1. There seems to be pricing requirements for a number of items and services without firm specifications, including furniture and IT equipment.
 - a. Please explain how and when specifications and requirements will be provided.
Please refer to the specifications for the room modifications at the Traffic Operations Center Room Modifications on page 4. Cost Detail Item #2 shall be TOC Modifications with a LUMP SUM (LS) unit cost.

TRAFFIC OPERATIONS building room modifications

PROPOSED TOC @ OPERATIONS CENTER DETAIL
NOT TO SCALE

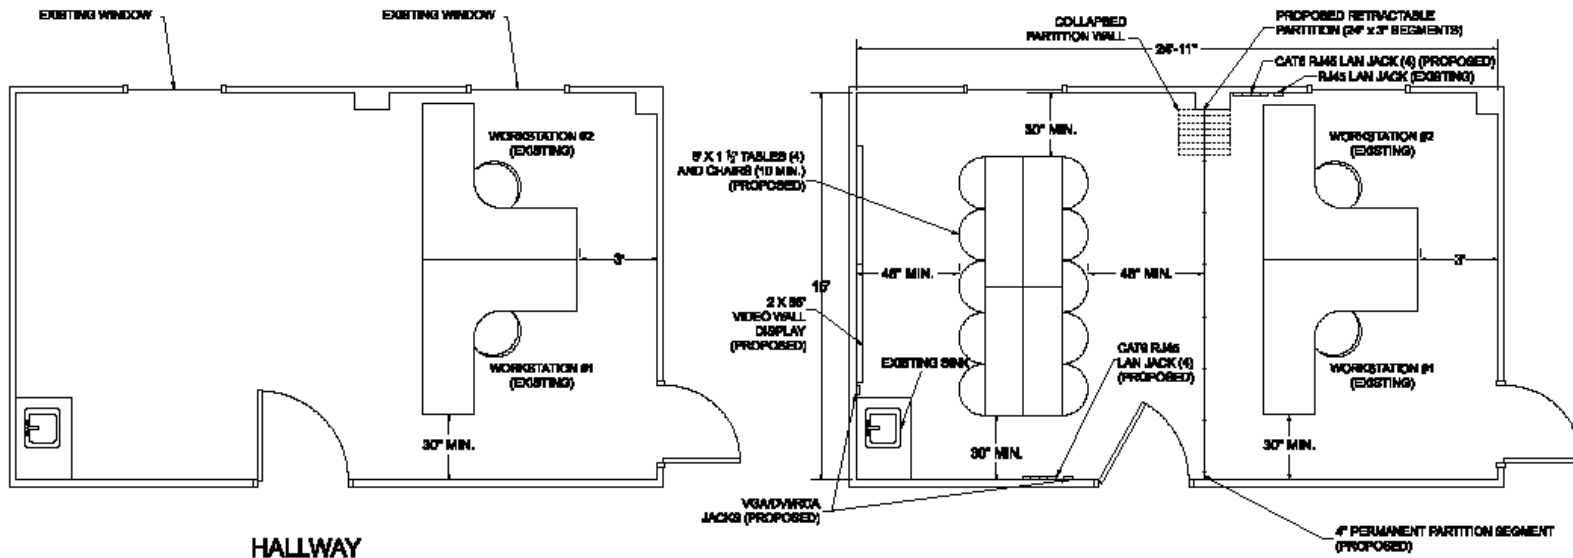
- 1. There are several references to the TOC regarding furniture, partitions, and construction but we could not find any detail as to the size, style, type and quantity required. **Please refer to the specifications for the room modifications at the TOC detailed on page 4.**

See Attached TOC plan
